## Bierton Traffic Calming Consultation Responses

### Local Comments:

**Figure 3:** Scheme drawing 1 showing priority narrowing giving priority to inbound traffic

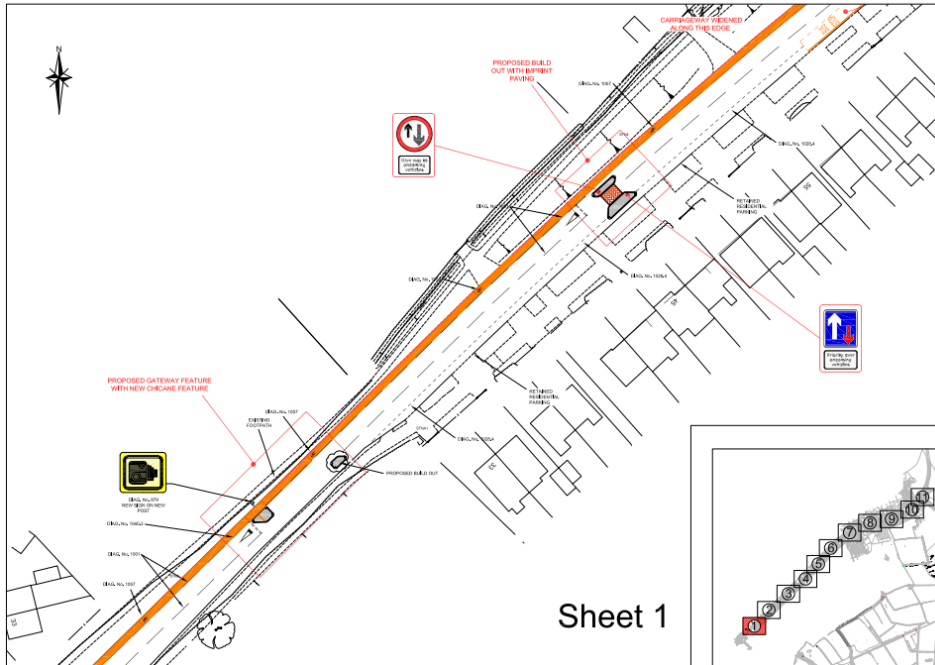
Given that the volume of traffic in either direction in a 24hr period is going to be in the region of 8K, during the tidal times the predominant direction of traffic I am sure will lead to those drivers gap seeking.

**Figure 7:** Priority narrowing with on carriageway bus stop and imprint on junction and existing crossing which is to remain.

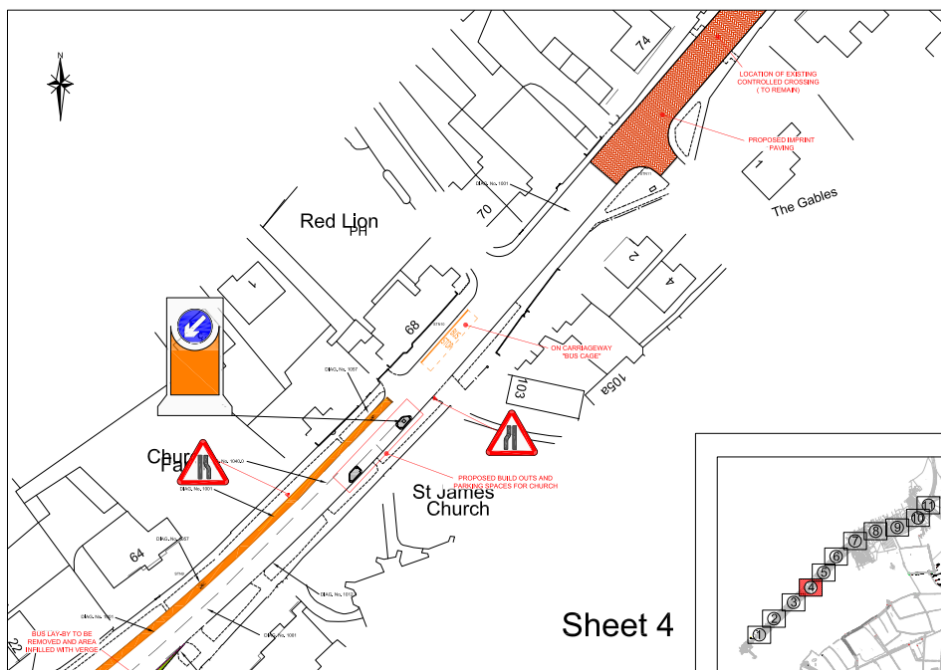
See comments for fig 1 ante.

**Figure 8:** Priority narrowing with imprint paving at junction at existing crossing to remain.

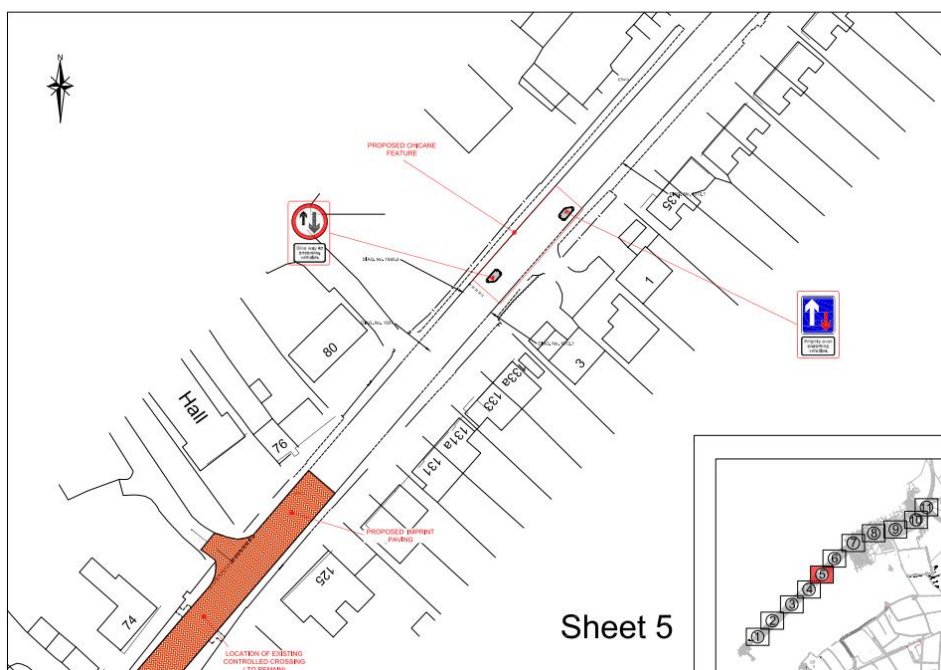
See comments for fig 1 ante.

**Figure 9:** Proposed build outs and imprint paving on informal crossing point

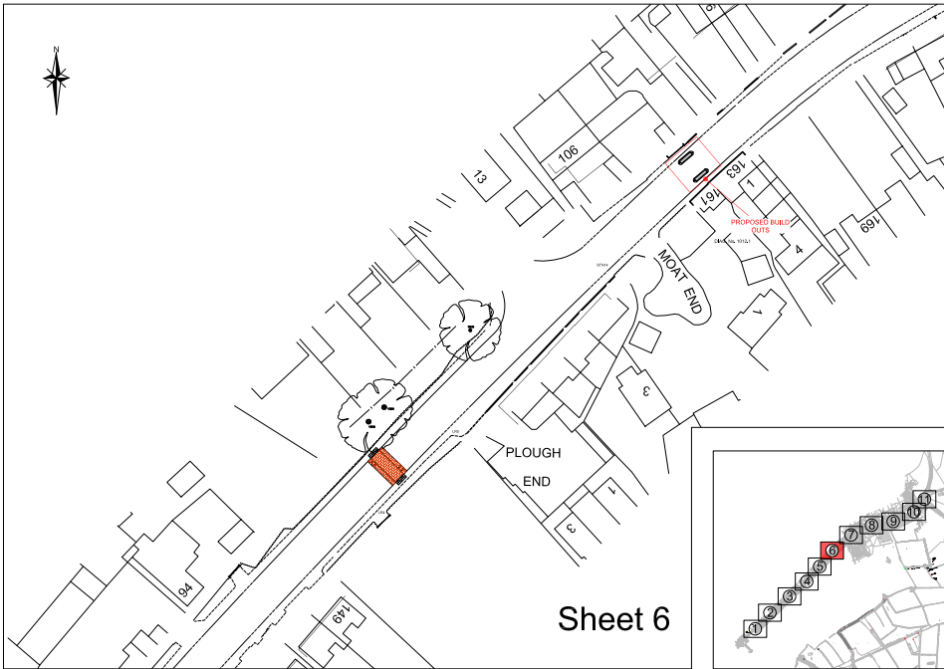
It is not clear what these build outs are but I assume to narrow the carriageway and slow vehicle speeds so would need more information to comment. The informal crossing point highlighted with red imprint paving has good visibility in either direction.

**Figure 11:** Bus stop to be made on carriageway and showing existing informal crossing point

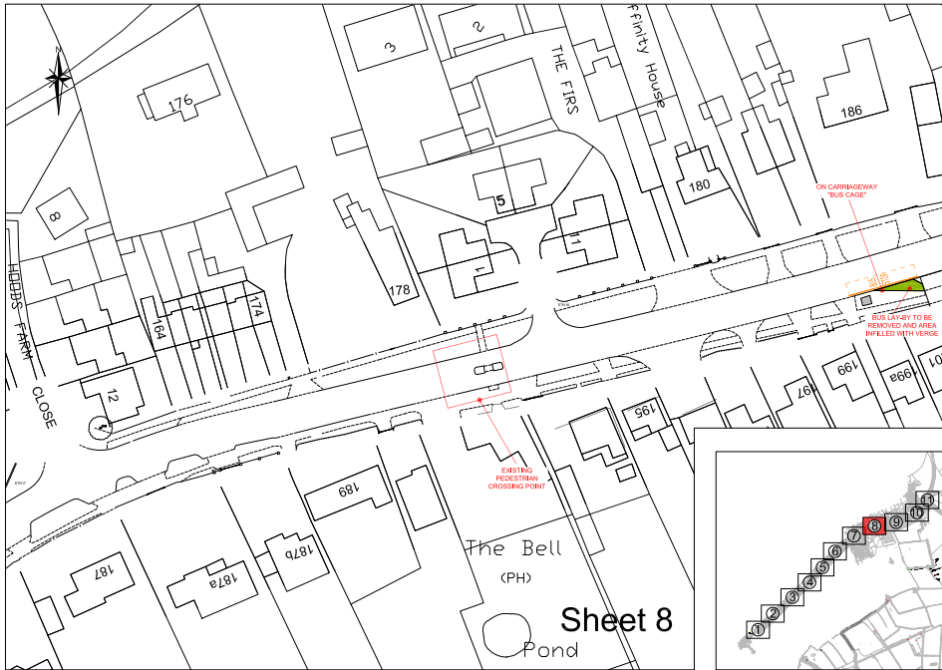
Comments as per fig 5 although not sure why no imprint for crossing at this location.

**Figure 12:** Re-location of bus stops to being on carriageway

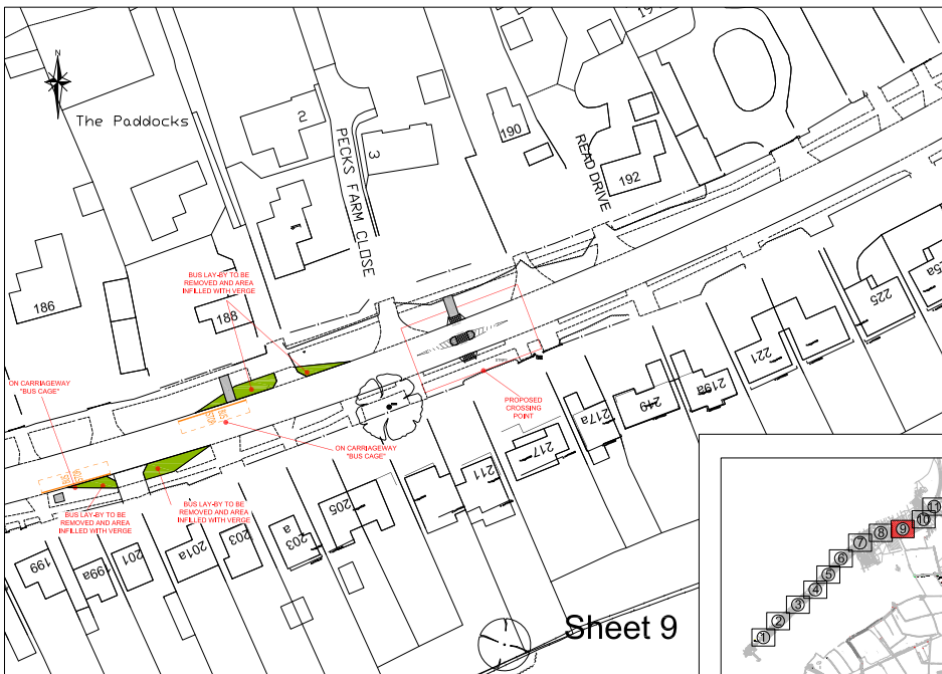
Comments as per fig 5.

**Figure 13:** On carriageway bus stop and gateway feature yet to be confirmed with warning sign for speed camera

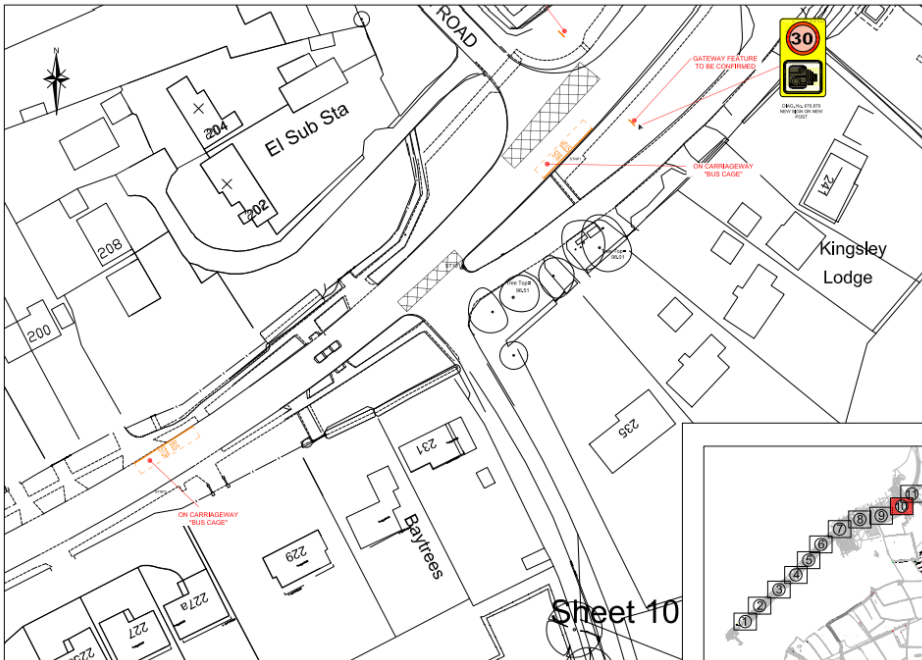
A gateway feature is useful in terms of advising drivers of a change in driving environment, so it is difficult to understand this as a location where there is development on both sides of the carriageway.

**Figure 14:** on carriageway bus cage with gateway features and speed camera warning sign

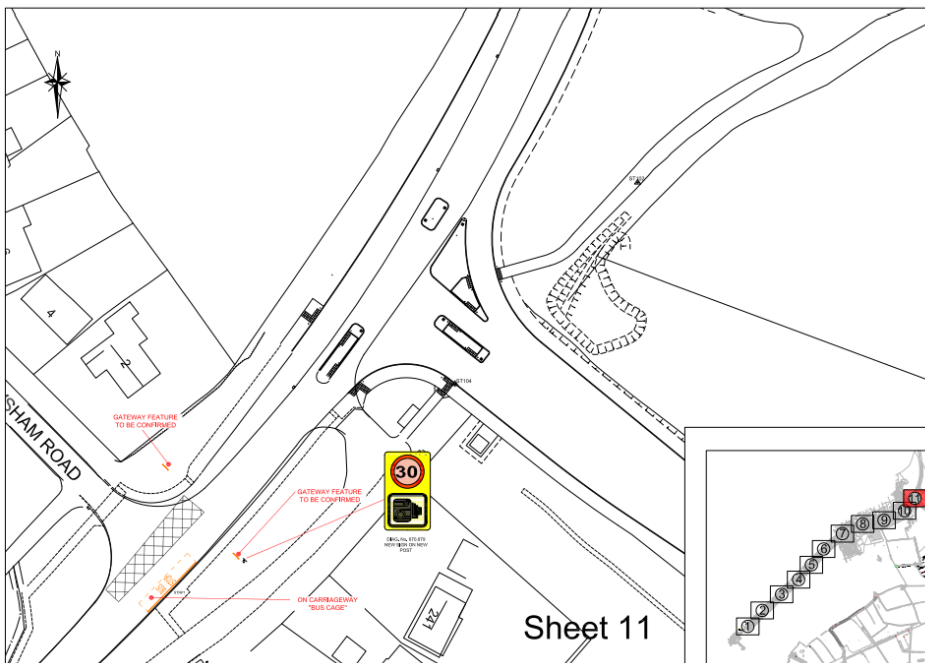
In order to gain the most impact on drivers for gateway treatments they should be stand-alone without any other signing clutter so the driver becomes aware of the change in driving environment.

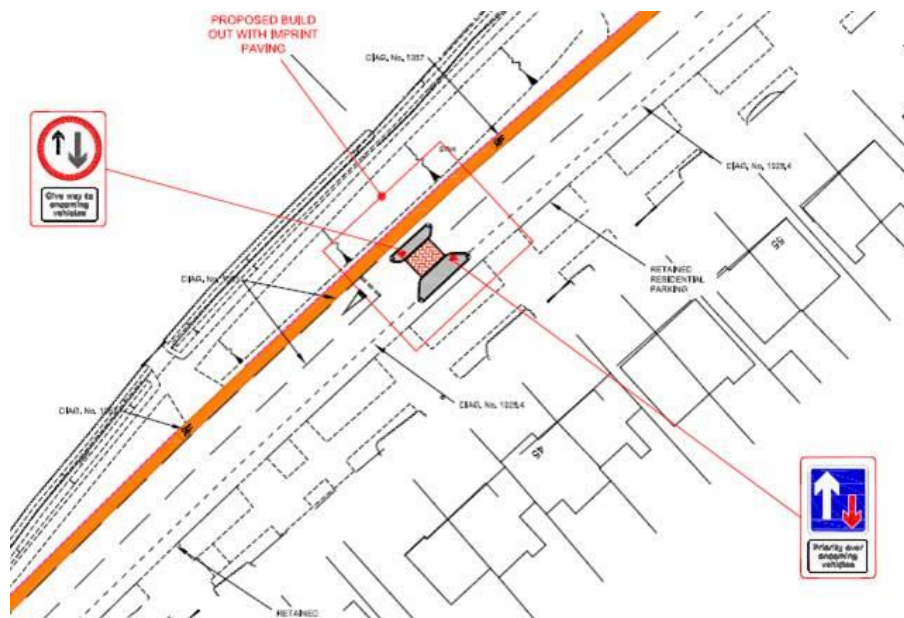
- This priority feature looks tight, will delivery vehicles / buses be able to negotiate the narrowing when moving from rest?

- It have been a while since I was designing, but I am sure the line type 1001 is incorrect for centre / lane / warning lines. I would challenge the use of any longitudinal line in the centre of the carriageway, unless required to either guide road users though / around a feature or on the approach to a hazard.
- Seems to be unnecessary cessation of cycle route at bus stop. This could lead to cyclists overtaking stationary buses and coming into conflict with vehicles travelling in the opposite direction. With the work to fill in the bus lay-by there could be room / opportunity to have a cycleway bypass behind the bus stop.
- Sign pointing the wrong way, should be keep right. Also, is this in keeping with the surrounding environment?

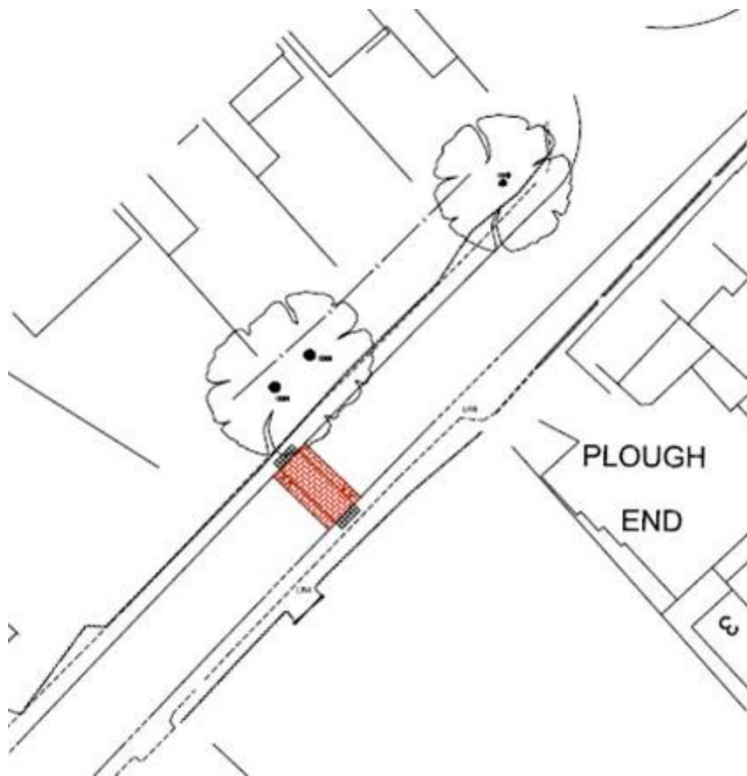
- Imprint paving will generate additional noise, with little / no reduction in speed, and introduce a maintenance liability. Is the underlying carriageway sound? If not, and this needs to be re-laid, could a coloured stone or similar be used? Is the expected skid resistance comparable with the existing surface considering the proximity to the controlled crossing?
- No details provide on this feature, assume it is a raised crossing?

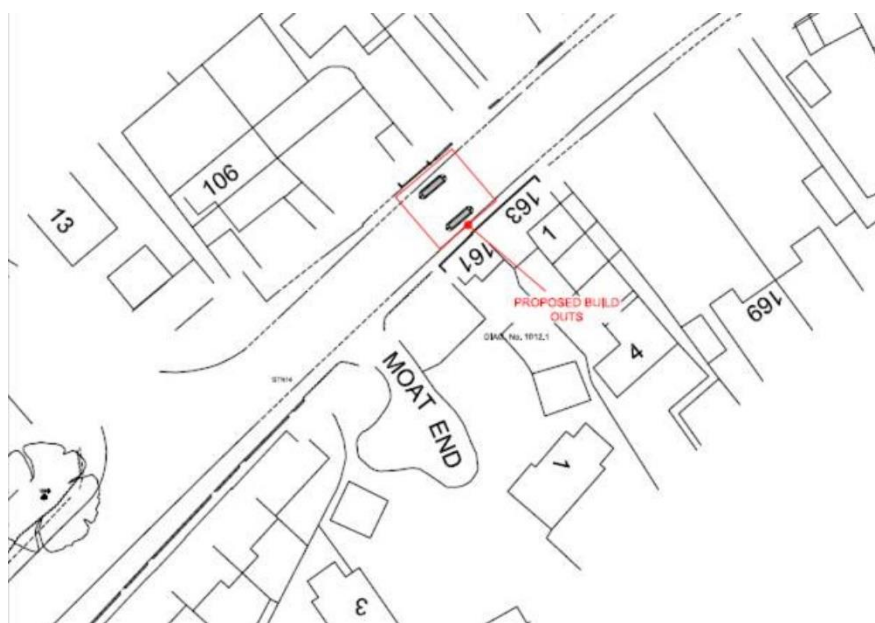
- These build-outs will be difficult to maintain, and detritus could build up between them and the kerb-line, increasing skid risk for cyclists.
